PlanGrid Task Report - Jul 19, 2024

Prepared by Stephen Tassinaro

Jul 19, 2024

Sheet
M-701

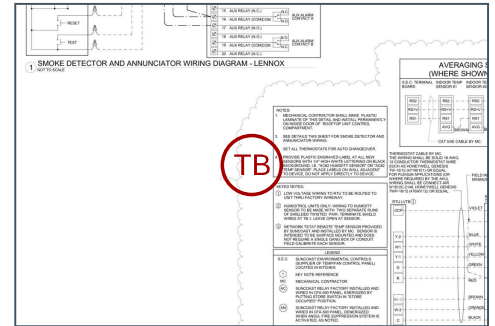
Description
Label all sensors, humidistats, thermostats, smoke annunciators and remote space mounted OADs, MODs, VFD's for which piece of equipment they serve.

M-201

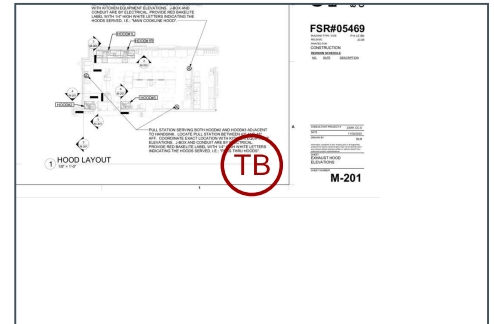
Label all ansul pull stations for which hoods they serve.

Sheet
M-501

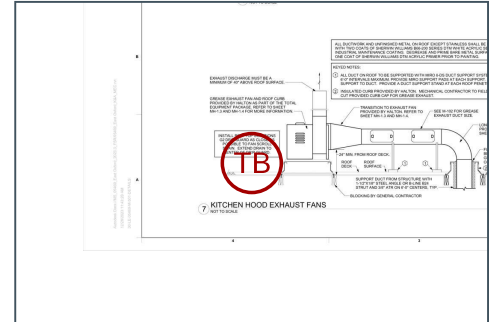
Description
Exhaust fan drain is not properly installed, pitched, or routed to center of drip guard per detail. If gas piping is used, will need to be painted for rust protection.

MH-1.1

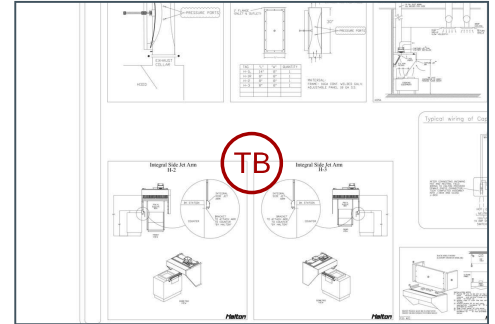
The Halton supplied angle bracket that connects the integral sidejet arm to the counter is missing or not installed correctly. Secure bracket to arm and bracket to counter underneath removeable fry dump via stainless steel rivets. Hoods 2 & 3.
